**DEVELOPMENT CONSENT AUTHORITY
PALMERSTON DIVISION**

AGENDA ITEM: **1** MEETING DATE: 14 August 2026 FILE: PA2026/0138

APPLICATION PURPOSE: 21 x 3 bedroom dwellings-group in 12 single storey buildings

SUBJECT SITE: Lot 13502 (6) Tuckeroo Boulevard, Zuccoli, Town of Palmerston

Nominated (proposed) locations of air conditioning units within carports

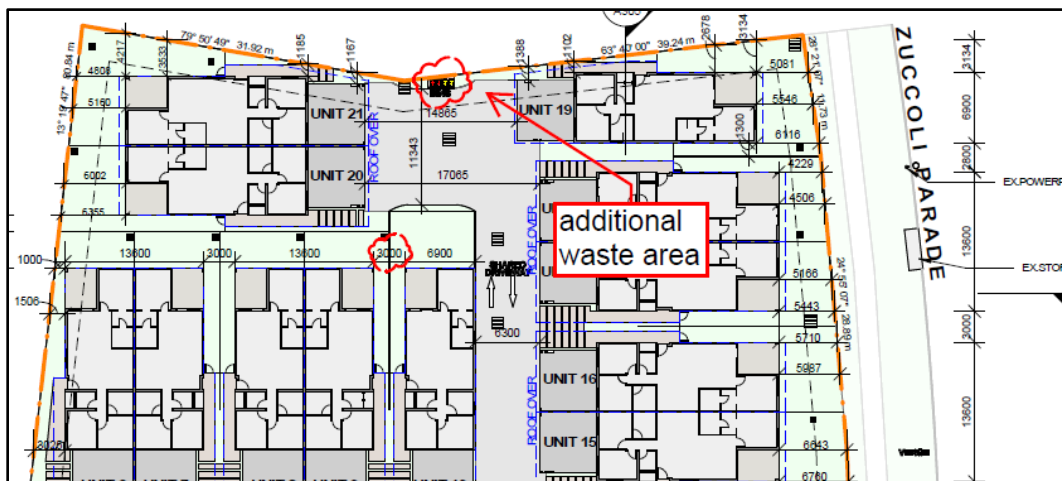
The application (as amended) indicates that the nominated dimensions of the car parking spaces within the proposed carports comply with these requirements. However, the drawings do not adequately demonstrate that the proposed air-conditioning condenser units, including their location, associated wall heights and required clearances, will not reduce the effective dimensions or functionality of the parking spaces. The location of these units also raises separate concerns regarding compliance with sub-clauses 5 and 6 of Clause 5.4.8.1 (Building Design for Dwelling-group, Rooming Accommodation and Residential Care Facility), discussed below.

Sub-clause 8(a) of Clause 5.2.4.4 requires a car parking area to *"be functional and provide separate access to every car parking space"*.

- the potential impact of air-conditioning condenser units on the effective dimensions and usability of the carports;
- the use of a reversing area within an otherwise pedestrian circulation area;
- restricted sightlines for vehicles reversing from adjoining parking spaces, particularly where solid walls or partitions separate parking spaces;
- the potential for simultaneous vehicle movements to create vehicle-to-vehicle or vehicle-to-pedestrian conflicts;
- pedestrian access to and from individual dwellings, including Units 12, 13, 19 and 21;
- the relationship between parking areas, landscaping and dwelling entrances; and
- the interaction between waste collection vehicles and the internal driveway and parking arrangement.

Non-compliant driveway widths

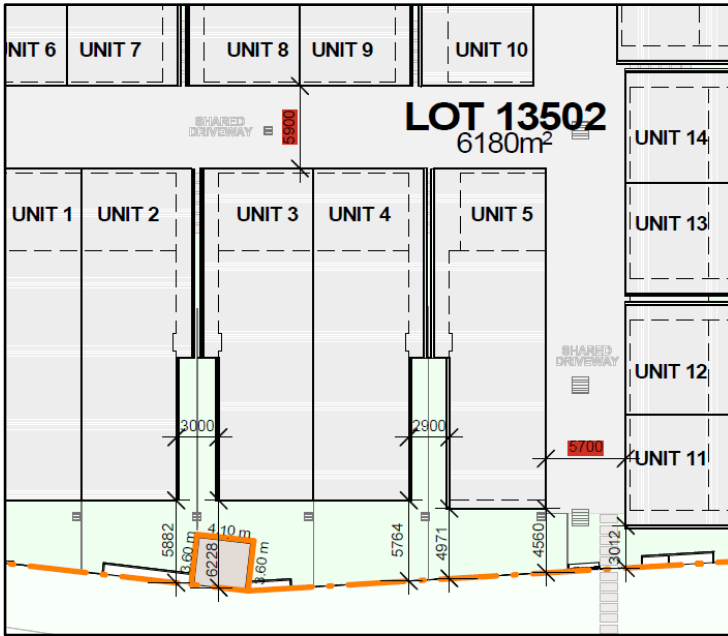
"The revised plans provided at APPENDIX A1 show functional parking areas consistent with the requirement of Sub-clauses 8 & 9 of Clause 5.2.4.4 (Layout of Car Parking Areas). The layout allows a vehicle to enter from and exit to a road in a forward gear. The proposed carports have minimum 5.4m entry access and 5.6m depth adequate to accommodate two cars."

DAS notes that the amended drawings indicate (see image below) driveway widths of approximately 5.9m and 5.7m between roof structures. More importantly, the drawings continue to raise sightline and pedestrian safety concerns within the parking areas. In particular, solid partitions between adjoining parking spaces has potential to restrict visibility between vehicles reversing from adjacent spaces. Where two vehicles reverse simultaneously, the restricted sightlines may increase the potential for vehicle-to-vehicle or vehicle-to-pedestrian conflicts.

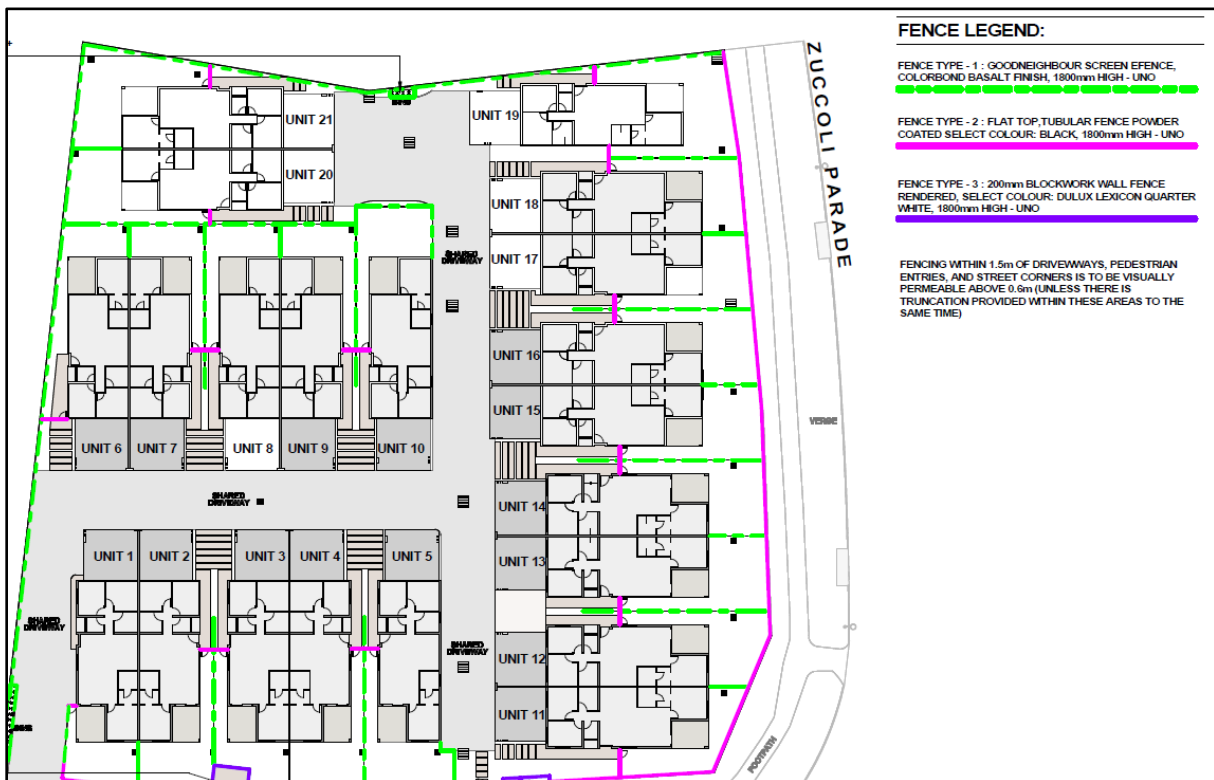
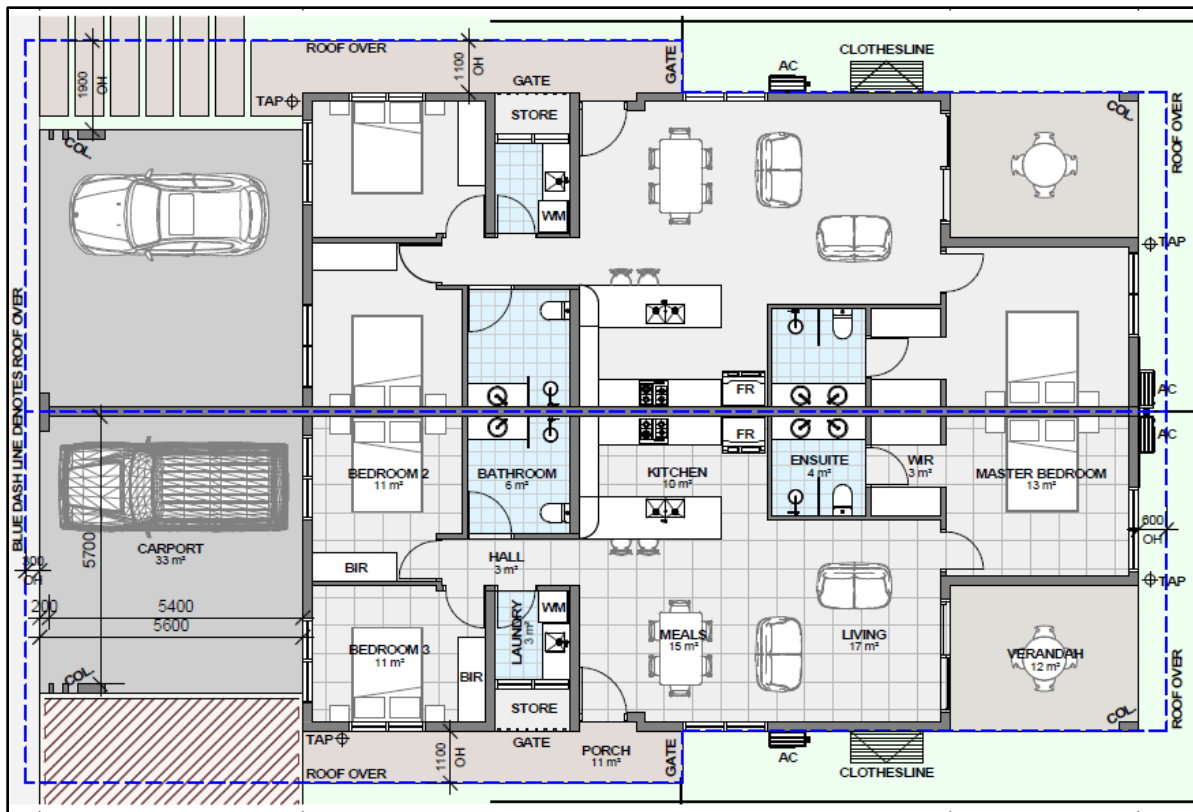
Additional drawings provided by the applicant (after a further information request) show the section of Units 11 through to 19, and their interaction between each other which shows that the stepping of the land has potential result in overlooking of adjacent private open space areas (image below).

The amended drawings from the applicant also shows solid fencing along the north and west boundaries and between units (image below). It is unclear how this design, along with the unit orientation and layout facilitates breeze penetration.

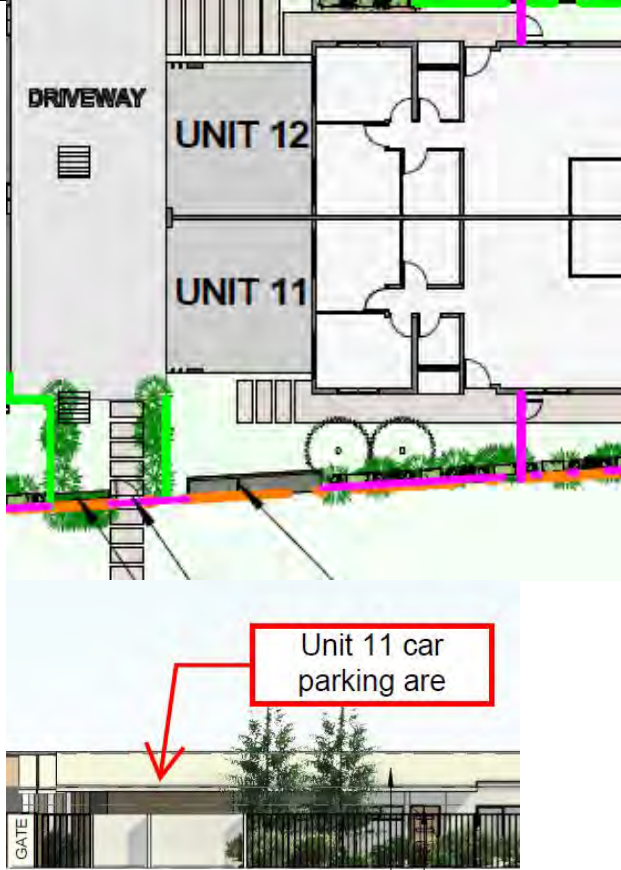
The top image is a site plan showing a driveway, Unit 12, and Unit 11. A red line indicates the 'Unit 11 car parking area'. The bottom image is a photograph of a blockwork fence with a red arrow pointing to it from a label 'Unit 11 car parking area'. It is noted that a ~1.8m high blockwork fence is proposed in this setback. The applicant has not requested a variation to this requirement. A condition can be included on the permit that requires landscaping to the depth of 3m within the boundary setbacks of units 11 & 12 car parking area.

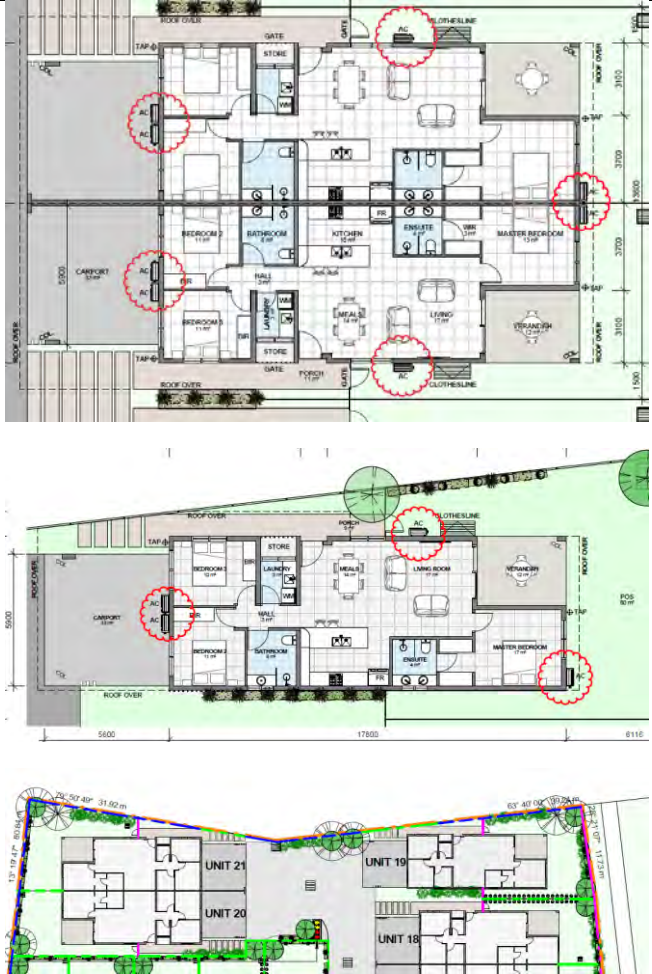
5.	Locate air conditioners where they are accessible for servicing.	Does not comply – the application shows the locations of the air-conditioning units on the ‘typical’ floor plans. While air-conditioning units for most dwellings are accessible, units 19, 20 and 21 do not provide convenient access to the associated unit’s air-conditioning units because access is blocked by carports, landscaping, retaining walls and the boundary (narrow). See additional comments regarding car parking layout.

6.	Conceal service ducts, pipes, air conditioners, air conditioning plants etc.	Does not comply/further information required – no service ducts or pipes have been shown on the submitted plans. The height placement of air-conditioning units have not been indicated on the elevations. The air-conditioning units in each car port is not considered to be concealed (from public view – eg: road reserves, Lot 12087, Lot 13503, common property areas). Further information is required that demonstrates the height of the proposed air-conditioning units.

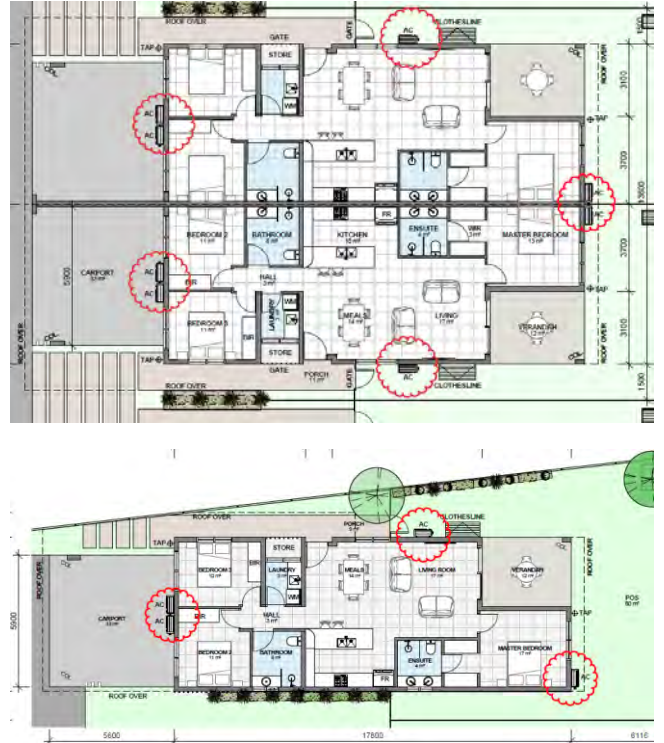
7.	Avoid overlooking of private open spaces and habitable rooms of adjacent residences on the same and adjacent sites .	Further information required - there are no residential uses on properties adjacent to the subject site - screening (screen fencing and landscaping) is proposed between dwellings on the same site. - Gradient of site / recent changes to site levels are not properly shown on drawings (terraced / stepped design / different levels of dwellings may create overlooking issues – visual amenity). Further information is required to show the

levels/gradients of the site.
8.	Locate bedrooms and private open spaces away from noise sources.	Does not comply – air-conditioning units are located next to bedrooms and within PoS areas.  See additional comments (under NTPS2020 private open space heading) regarding interface of dwellings with existing and proposed use / works on Lot 13503. Units 11 to 19 will have an interface with a busy road (Zuccoli Parade), no noise attenuation measures in place (see comments below).
